Re: Second Submission Review: Parklands Village 1 Phase 2 – Site Plan and Plat
Application Number: DA-2289-06
Case Numbers: 2024-4015-00; 2024-3028-00

PARKLANDS VILLAGE 1 SITE PLAN NO. 2

PARKLANDS VILLAGE 1 SUBDIVISION FILING NO. 2

LEGEND

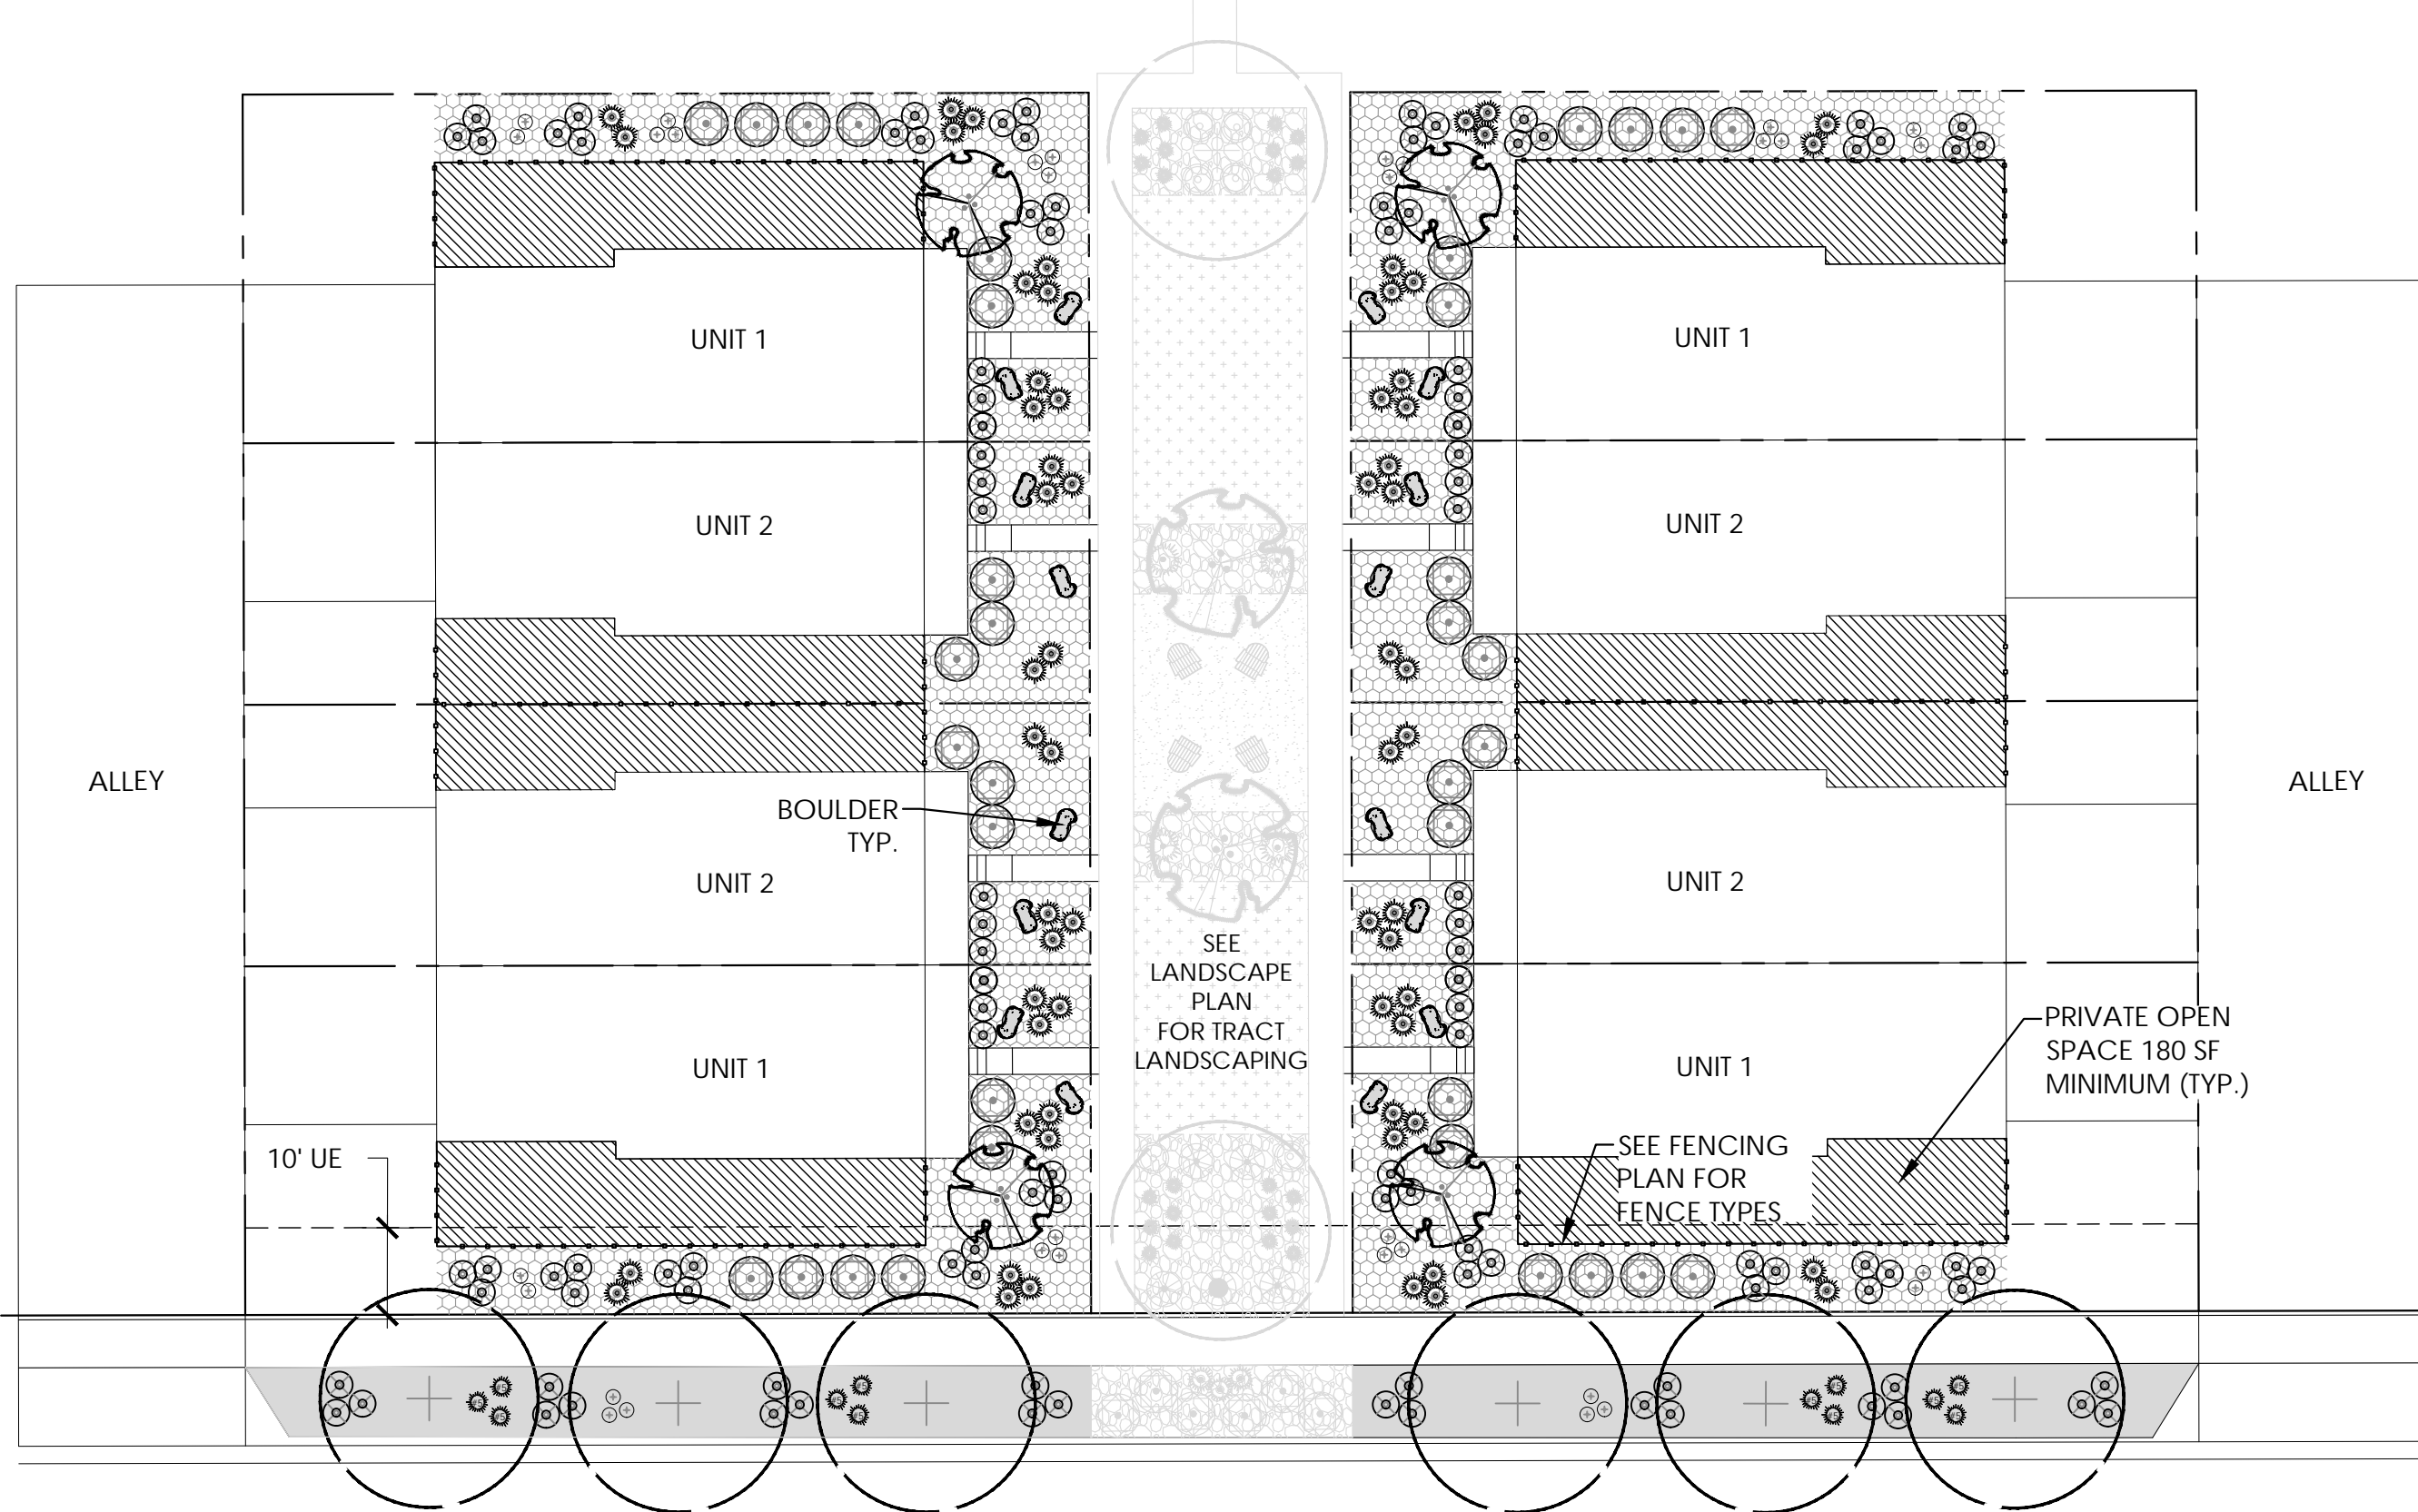
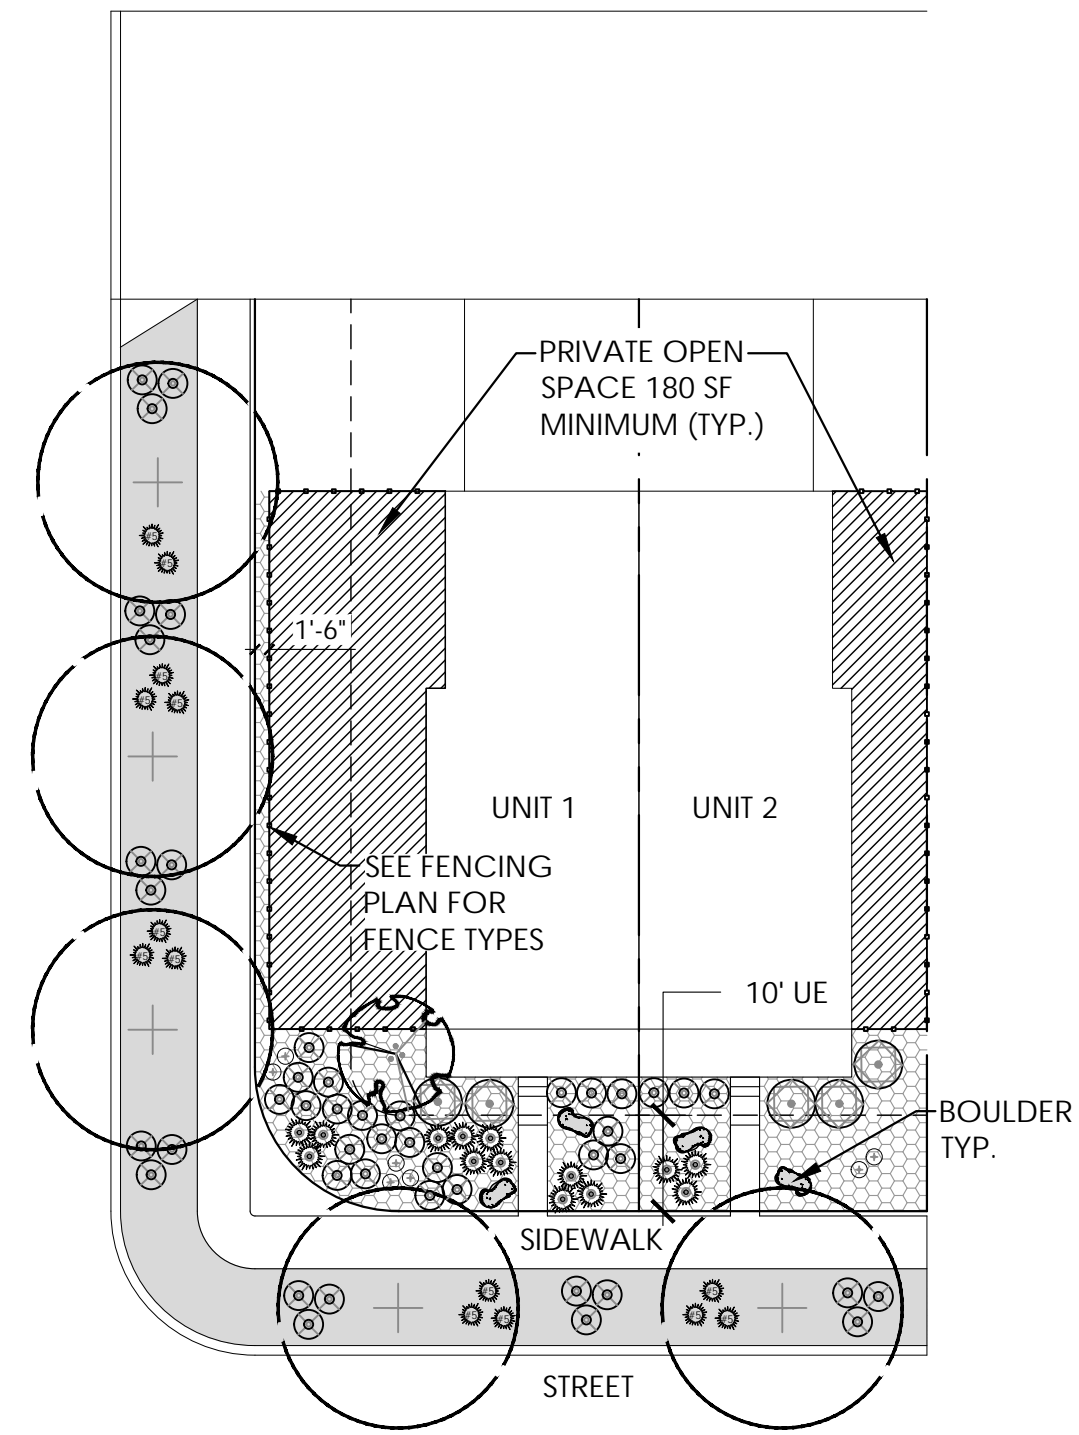
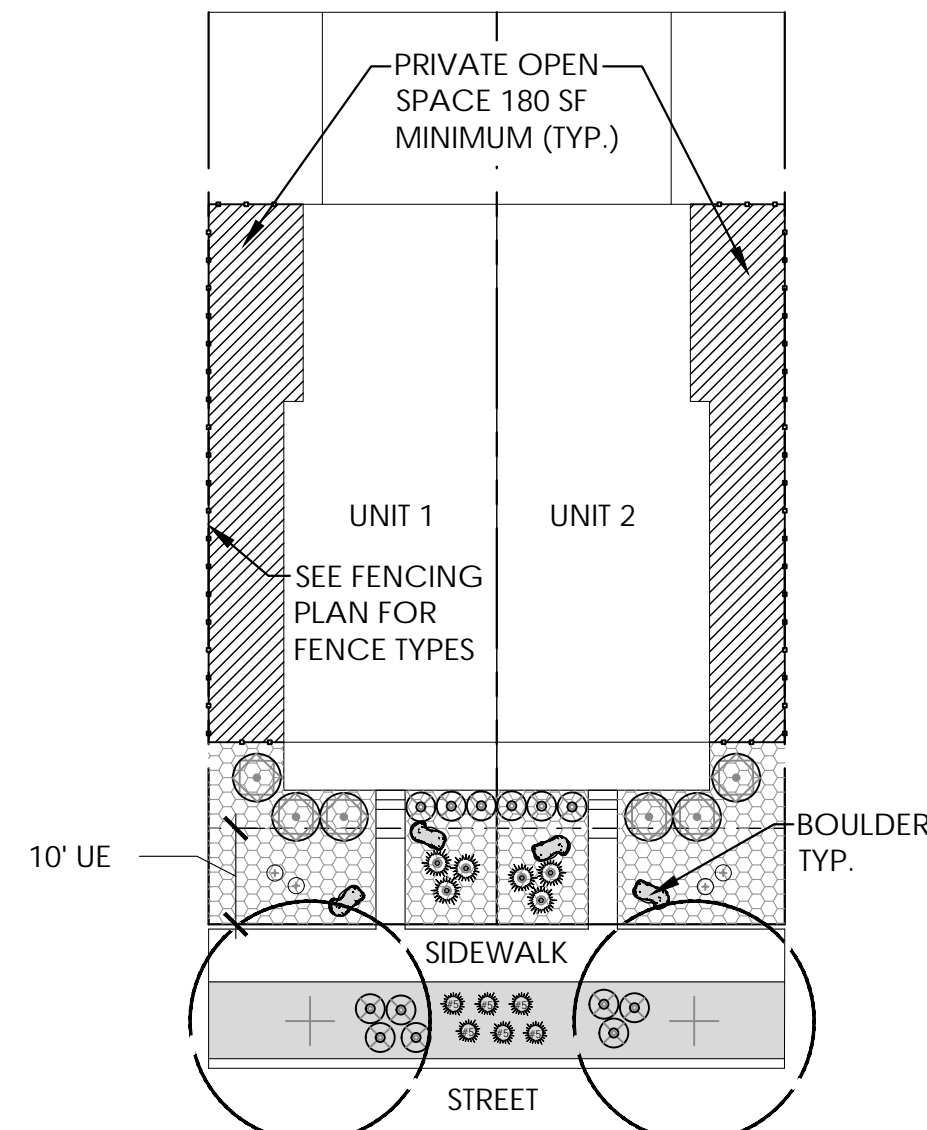
On each lot typical label include all utility connections. Provide a legend on this plan sheet as well with the symbology being used to represent this information. Include all the plant symbols as well.

Note two boulders as the special feature in each yard. Typ.

No more than 40% of the shrubs can be ornamental grasses can be included in the curbside landscape area.

RESPONSE: ADDED UTILITIES ON PLANS AND LEGEND AND ALL PLANT SYMBOLS ON SHEET 24

RESPONSE: ADDED

Table 11 – Turn Lane Warrant and Length Summary

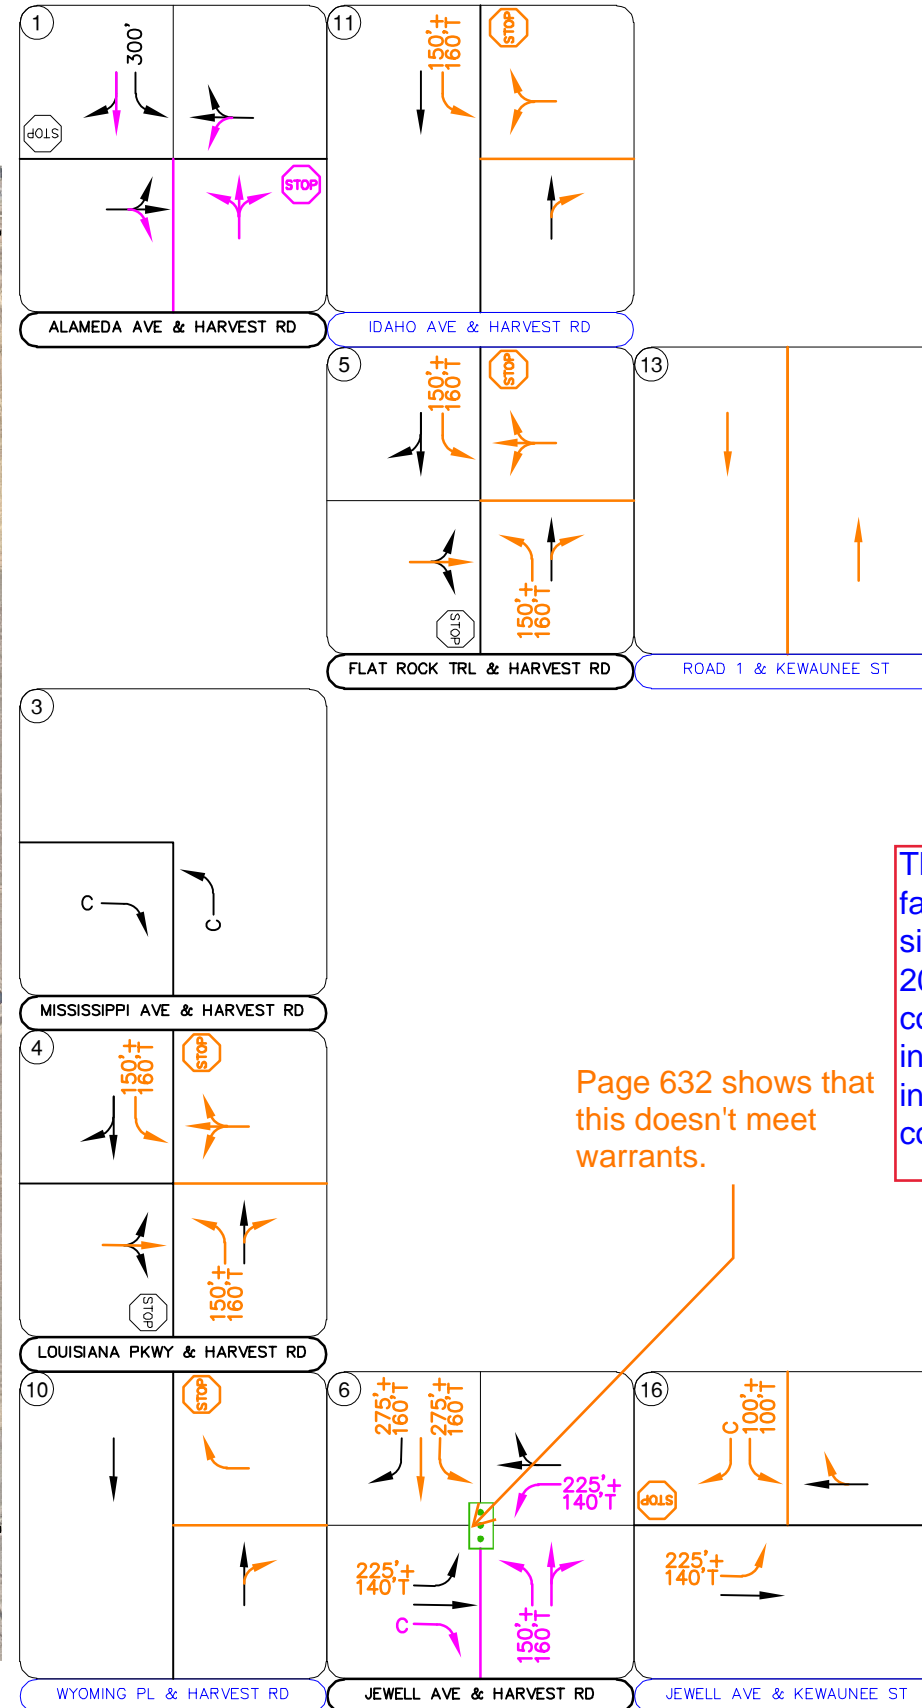
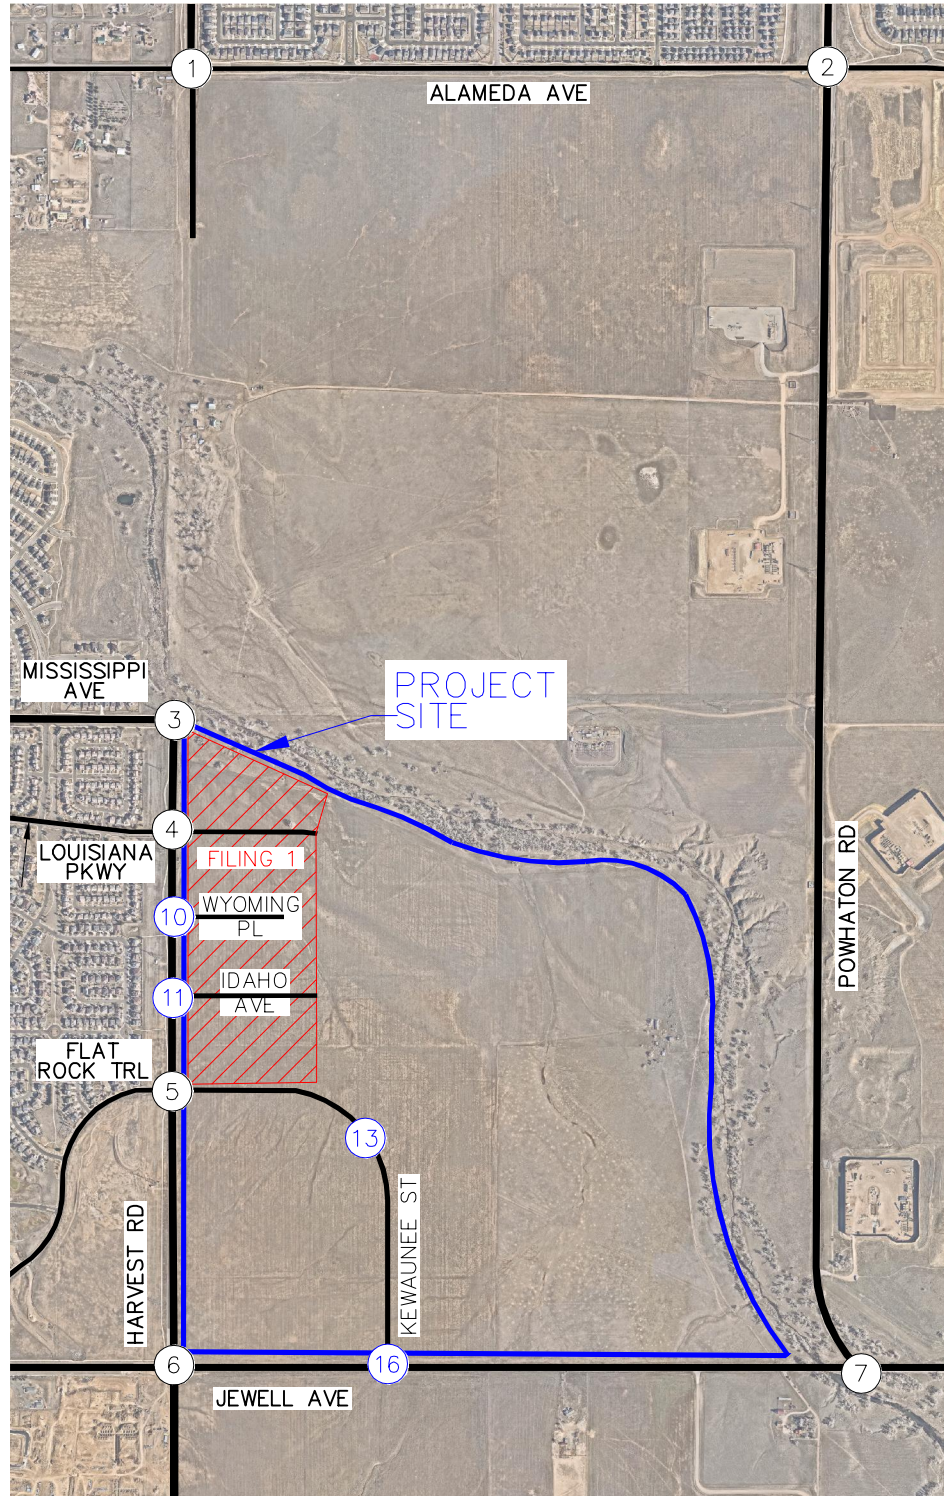
7E. Alameda and Powhatan Road eastbound right is meeting warrant volumes for an aux lane between the years 2026-2029. This is not addressed in the report and is not a recommendation to be added.

This is meeting the turn lane volume requirement. The report doesn't address that.

The explanation was previously provided in the second bullet point in each of the 2026, 2027, 2028, and 2029 Turn Lane Evaluation Sections on pages 81 and 82, respectively. The through volumes are nominal and this lane essentially serves as a right turn lane. Further, the intersection operates well without the right turn lane and it is a temporary condition as a right turn lane is not warranted once Mississippi Avenue provides through connectivity in the area.

The signal being accelerated to 2026 is due to failing movements with stop control in 2026. The signal is not warranted based on volume until 2028. With this only being two years later, signal control could be considered sooner to allow for this intersection to operate acceptably. However, the intersection has been recommended with stop control.

WARRANT 2 -- Four Hour Volume Warrant - Figure 4C-1

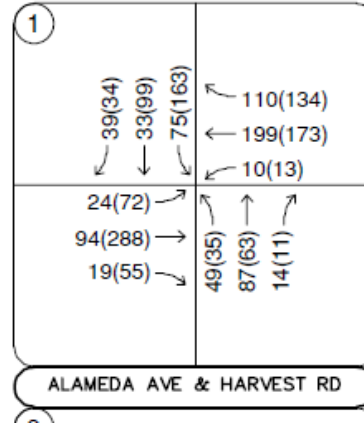
This still shows that it doesn't meet criteria. Figure 24 shows it being signalized.

The signal being accelerated to 2026 is due to failing movements with stop control in 2026. The signal is not warranted based on volume until 2028. With this only being two years later, signal control could be considered sooner to allow for this intersection to operate acceptably. However, Figure 24-25 have been updated to include two-way stop control and Figure 26 identifies the warranted signal.
